From: Andrea Grenier <Andrea@agrenier.com>
To: "John Kessler" <Jkessler@energy.state.ca.us>, "Mark Hesters" <Mheste...
CC: "Jeff Benoit" <jeffrey.benoit@solarreserve.com>, "BruceCenturino" <b...
Date: 7/16/2010 5:58 PM
Subject: RE: FW: Solar Reserve Data Request Follow Up
Attachments: Rice Plots for CEC_1.pdf

After reviewing the submittal, we have the following comments:

In response to Ajoy Guha's email request dated 7/14/2010 – Response provided by Solar Reserve using Western data:

Figure 21

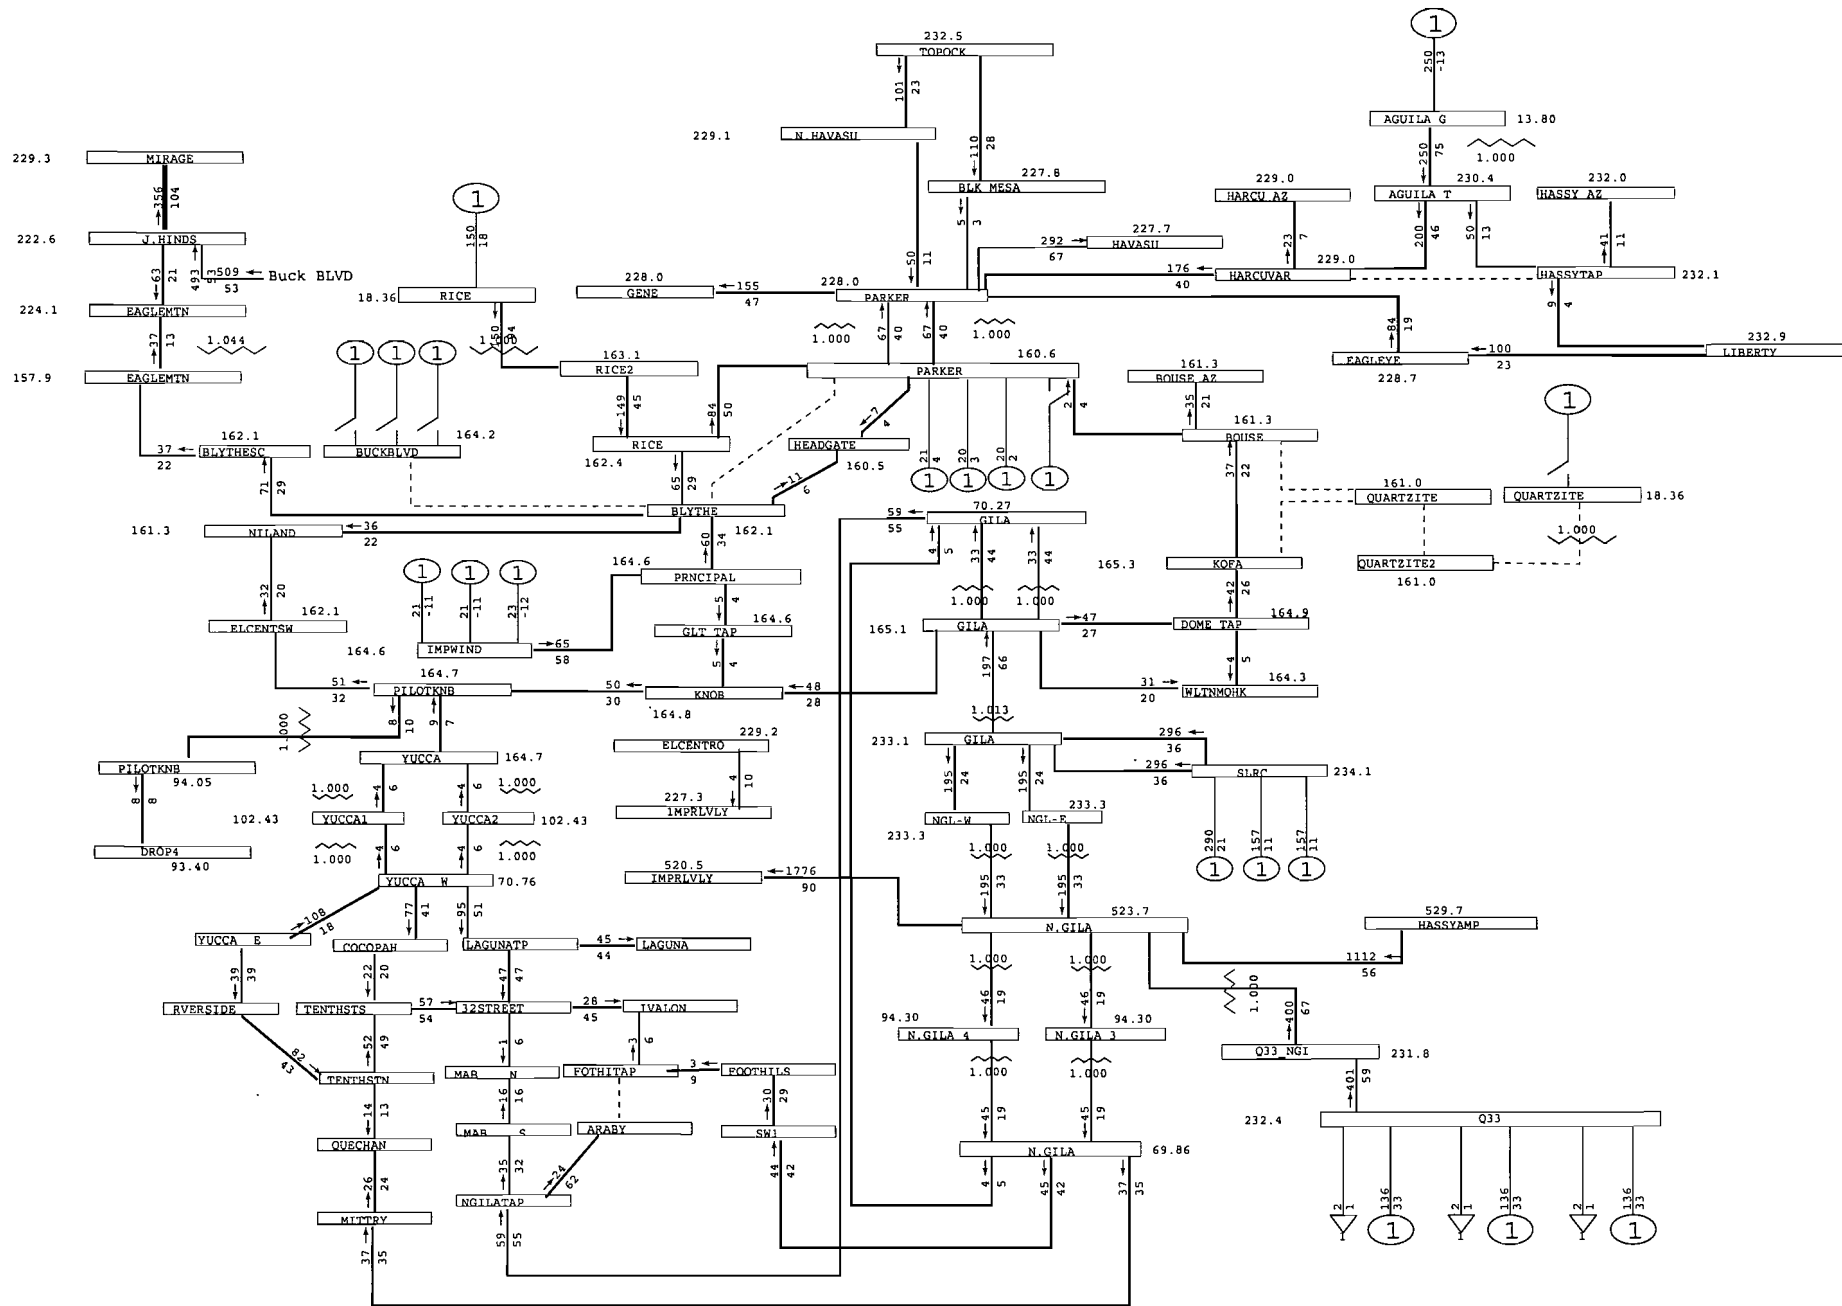
1. About 13 HS Base Case with Quartzsite Gen off:
 - a. Load Flow diagram for the Base Case with RICE ON is not included.
 - b. Load Flow diagrams for Category B outage of the Palo Verde-Colorado River 500 kV line (with all identified overloaded elements) not included

- 1) 13 HS Base Case with Quartzsite Gen off:
 - a. Load Flow diagram for Base Case with RICE ON – Included in Figure 21
 - b. Load Flow diagram for Category B outage of the Palo Verde-Colorado River 500kV line – Included in figure 22 (Pre-Project) and 23 (Post-Project)

Figure 24

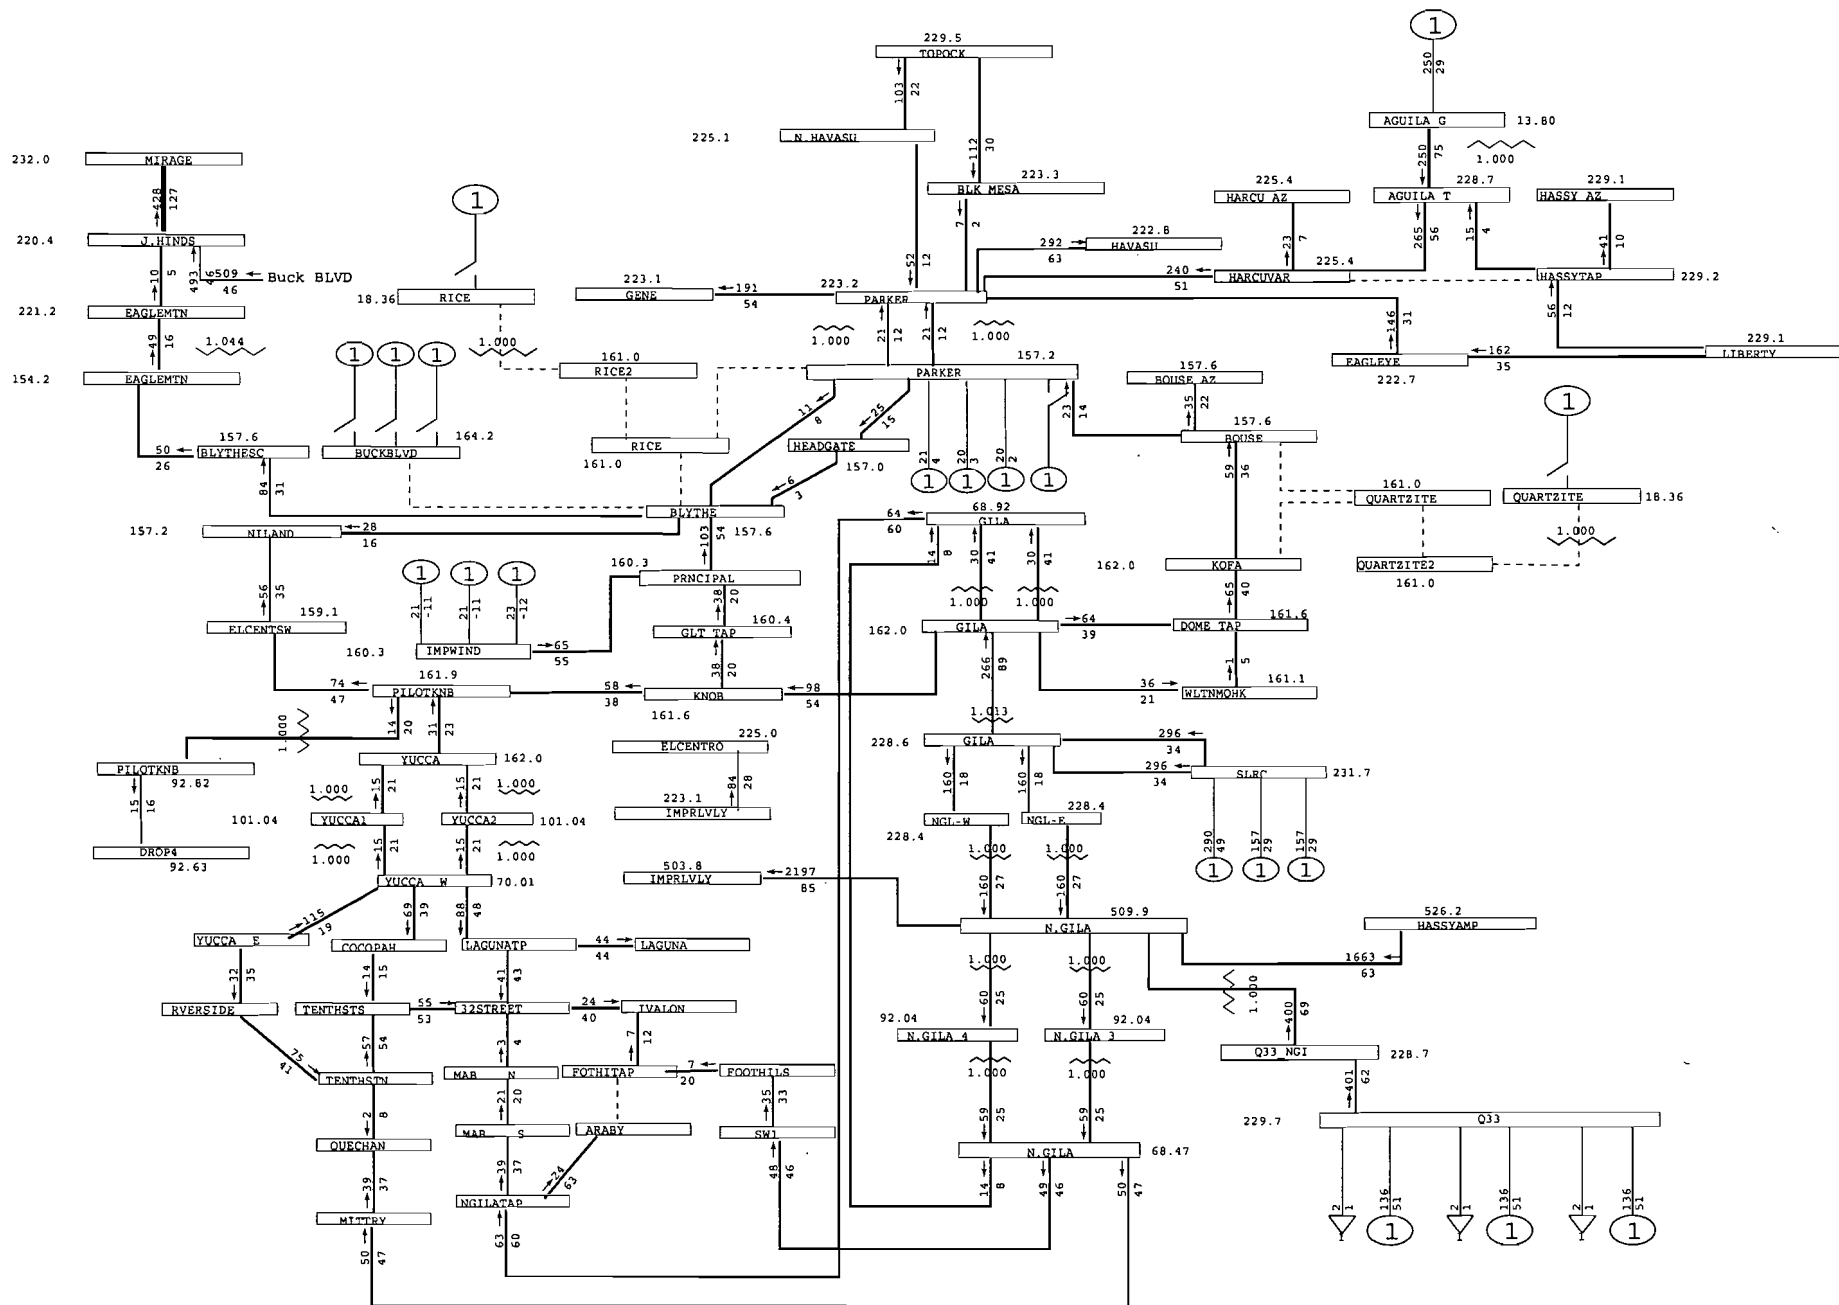
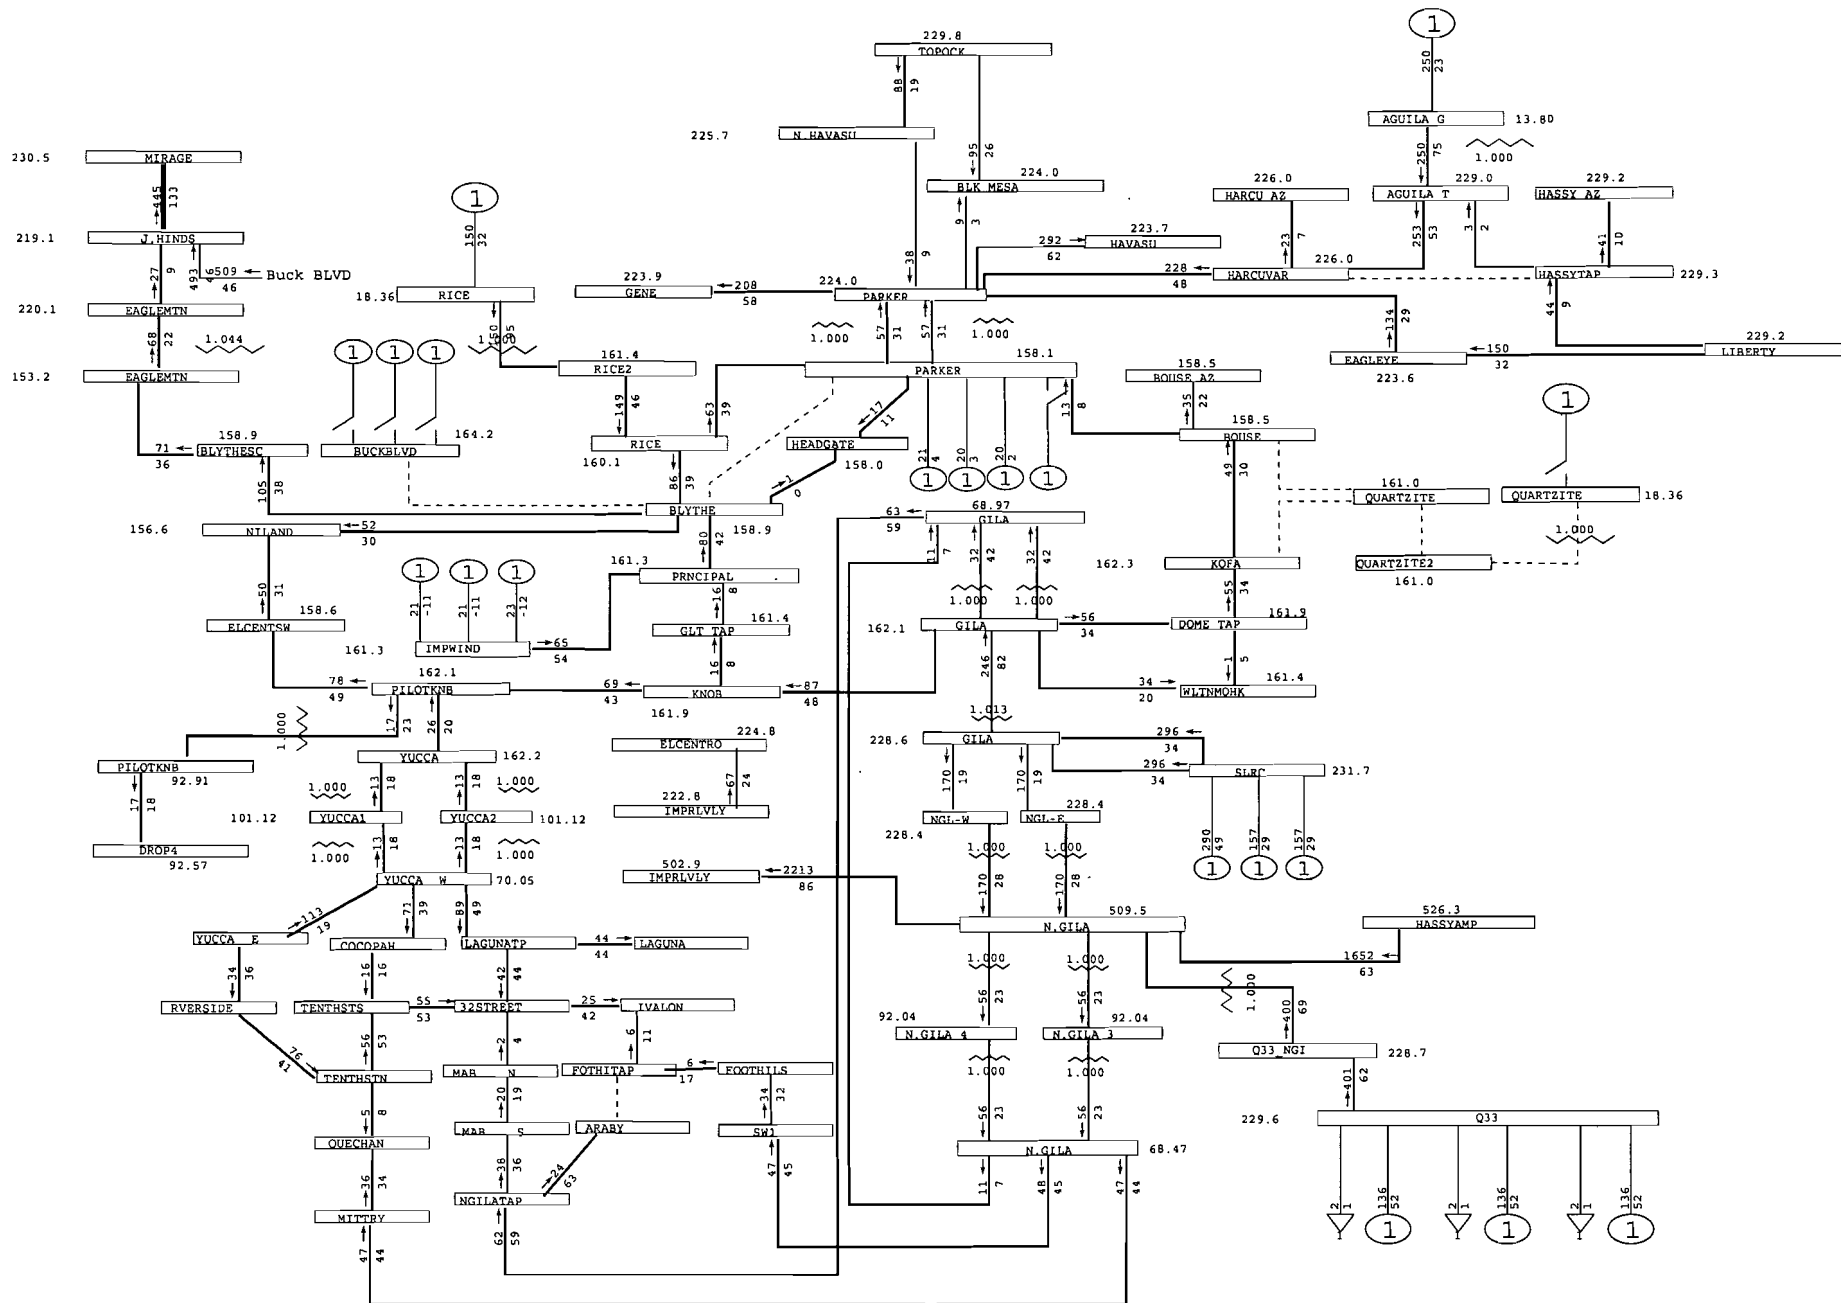
2. About 13 HW Base Case with Quartzsite Gen off:
 - a. Load Flow diagram for the Base Case with RICE ON is not included.
 - b. Figures 12 & 13: N. Gila-IV 500 kV outage case-Table 8 in the SIS report shows pre-project overload on the IV-EI Centro 230 kV line which is not shown in the diagrams. This line may be included in all LF diagrams.

- 2) 13 HW Base Case with Quartzsite Gen off:
 - a. Load flow diagrams for the Base Case with RICE ON – Included in Figure 24
 - b. Figures 12 & 13: N. Gila-IV 500 kV outage case- Table 8 in the SIS report shows pre-project overload on the IV-El Centro 230 kV line which is not shown in the diagrams. – Included as Figures 25 (Pre-Project) and 26 (Post-Project)

Figure 28

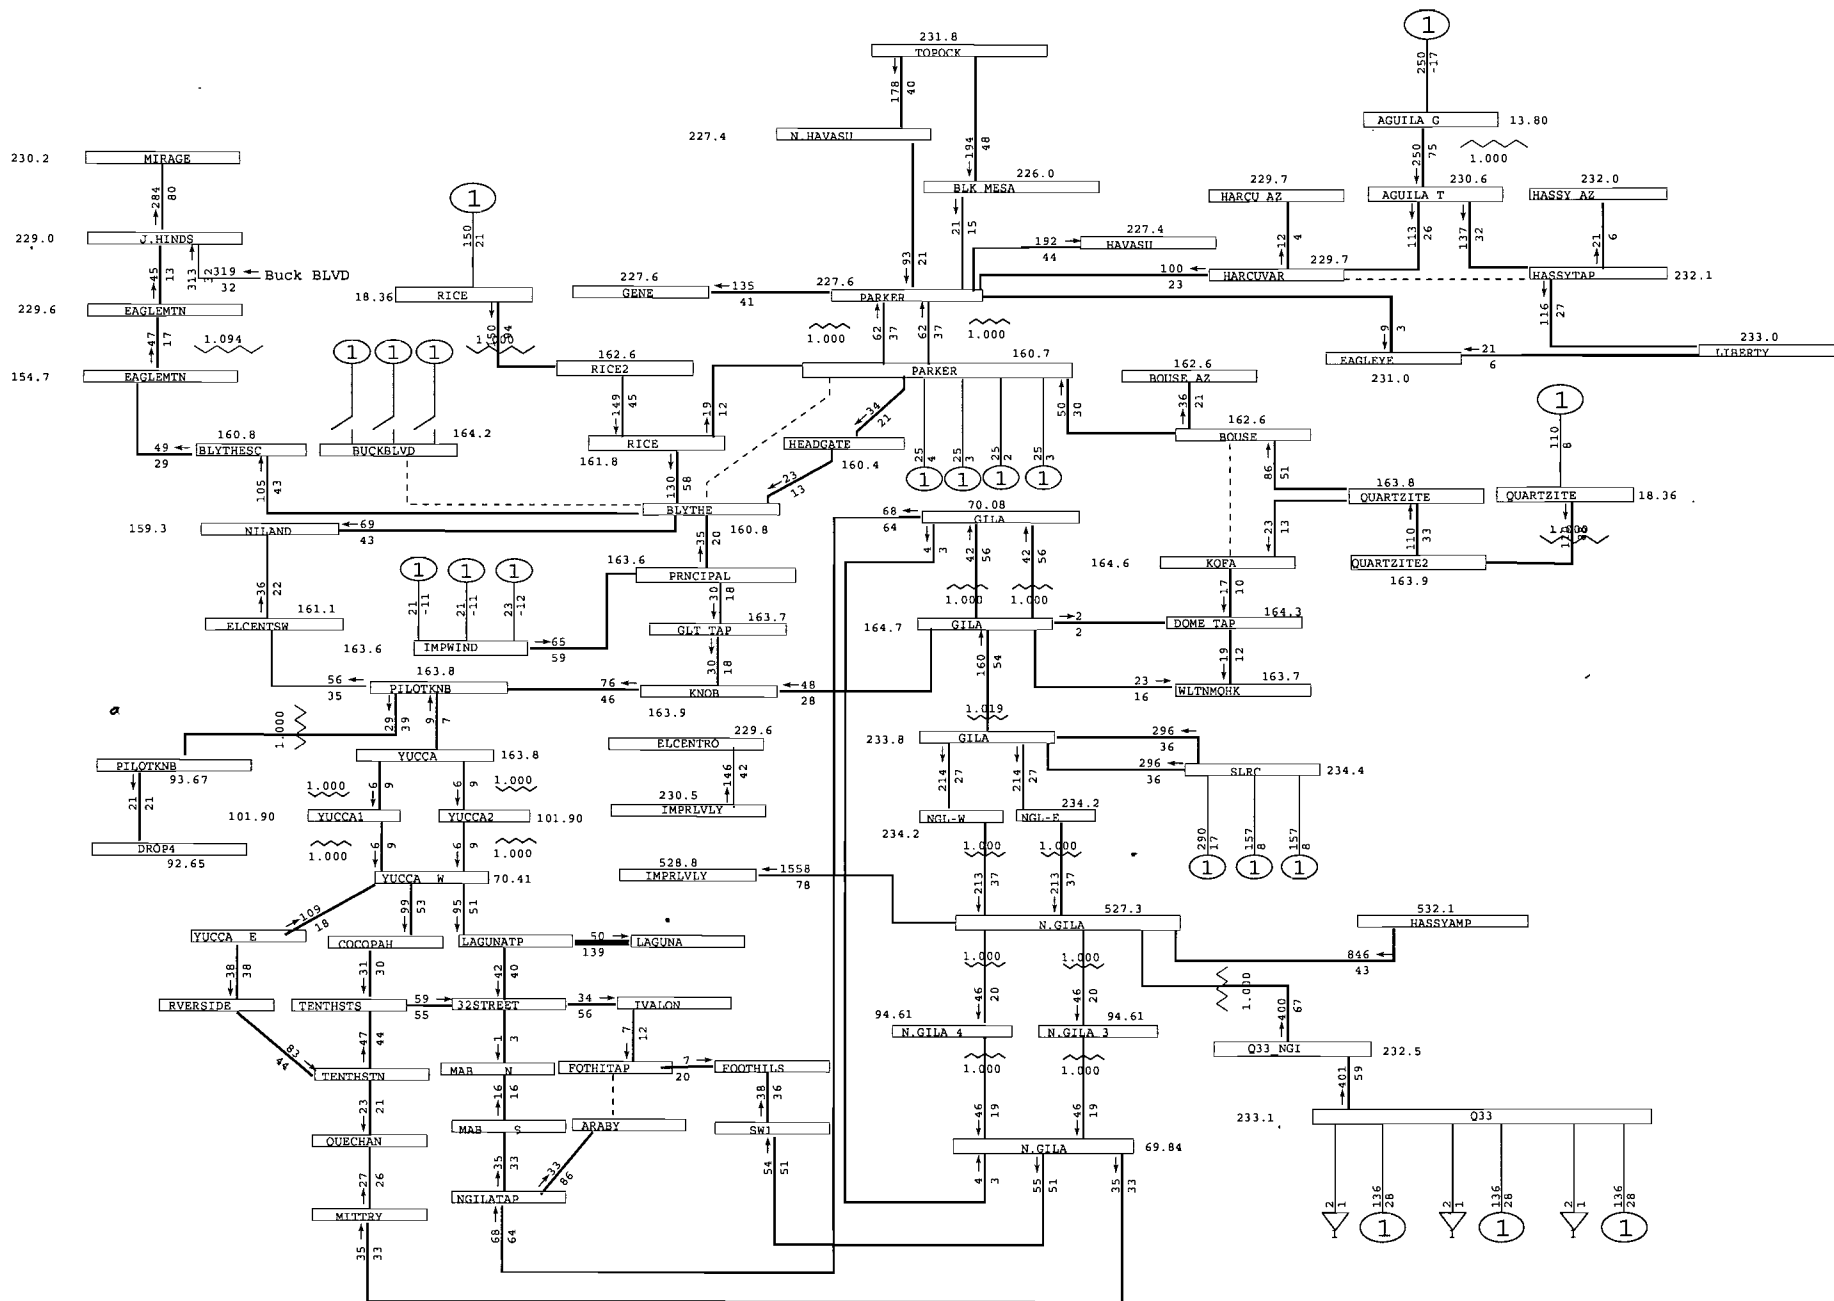
- c. Load Flow diagrams for Category B outage of the Palo Verde-Colorado River 500 kV line (with all overloaded elements) not included.
 3. About 13 HS Base Case with Quartzsite Gen on:

- c. Load flow diagrams for Category B outage of the Palo Verde-Colorado River 500 kV line – Included in Figure 27 (Pre-Project) & 28 (Post-Project)
- 3) 13 HS Base Case with Quartzsite Gen on:

Figure 37

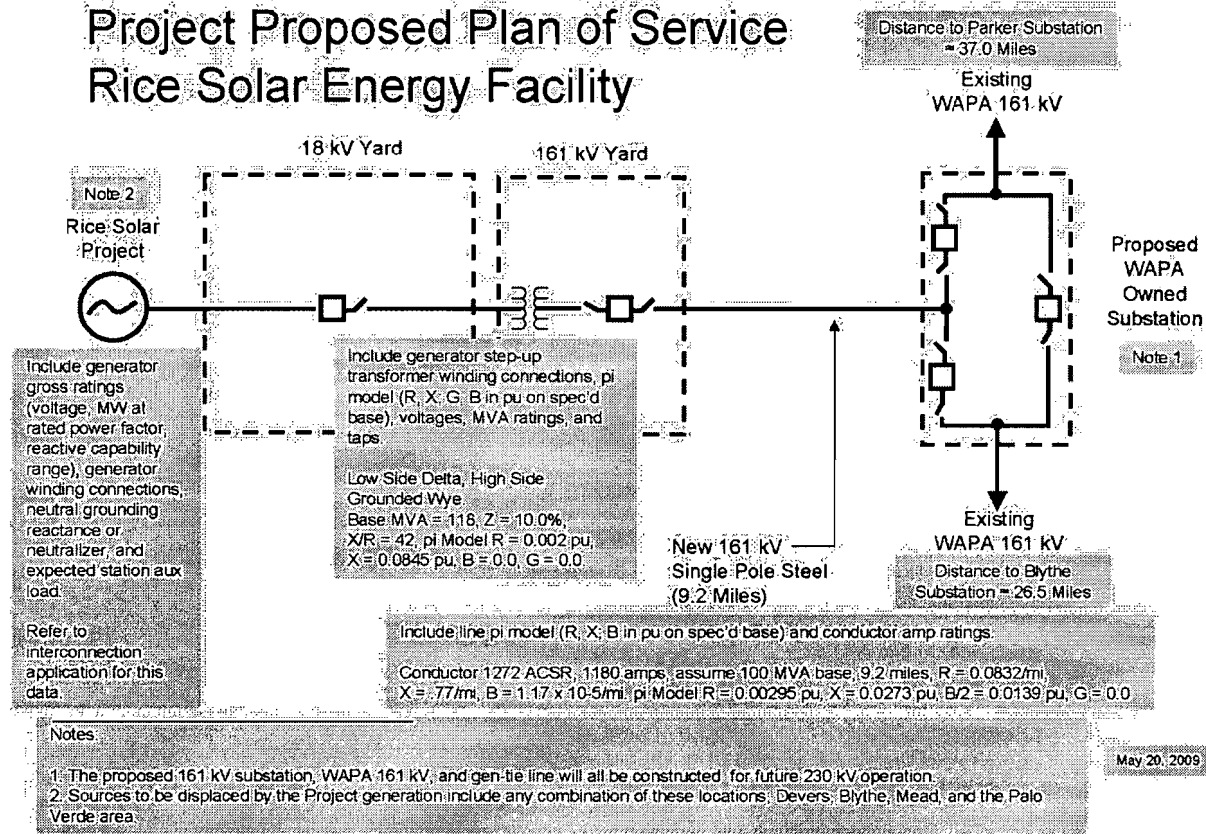
- a. Submit letters from SCE and IID with their comments about the SIS and the proposed mitigation, if any.
- b. About the base cases of the SIS, mention or show in a one-line diagram the major interconnection details modeled for the RICE Solar Energy project (RSEP) to the Western grid (such as amount of net RSEP generation, the step-up transformer size and impedance, mileage of the new Gen Tie line and size of its conductor, lengths of the existing Parker-Blythe 161 kV #1 line from the Blythe and Parker substations respectively to the proposed new RICE substation point of interconnection etc) and if all planned transmission upgrades up to 2013 in the Western and California ISO grids have been included and if all major Path flows are within limits. Also mention construction responsibilities of the interconnection facilities between the applicant and Western.

- b. Mention of show in a one-line diagram the major interconnection details modeled for the RICE Solar Energy project (RSEP) to the Western grid (such as amount of net RSEP generation, the step-up transformer size and impedance, mileage of the new Gen Tie line and size of its conductor, lengths of the existing Parker-Blythe 161 kV line from Blythe and Parker substations respectively to the proposed new RICE substation point of interconnection. – Included in Figure 37
